191st session
Geneva, 14–16 November 2023
Item 4.7.1 of the provisional agenda
1958 Agreement:
Consideration of draft amendments to existing
UN Regulations submitted by GRSG

Proposal for 02 series of amendments to UN Regulation No. 160 (Event Data Recorder)

Submitted by the Working Party on General Safety *

Corridor +/- 10 Per Cent of the Full-Scale Range of the Accelerometer

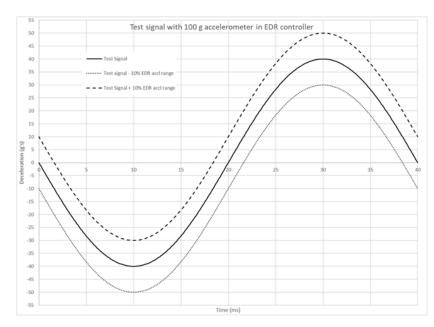
6.1.5. The EDR recorded acceleration trace shall be fully contained in a corridor that is +/- 10 per cent of the full-scale range of the accelerometer used by the controller containing the EDR applied to the component test fixture's filtered acceleration trace. The comparison of acceleration sensor traces shall only be made on the axis the component test was conducted.

For example, if the accelerometer in the controller containing the EDR function has a +/-100 g range, then +/-10 g would be applied to the component test fixture's filtered acceleration trace. The EDR recorded acceleration trace shall be fully contained within that corridor (see the figure).
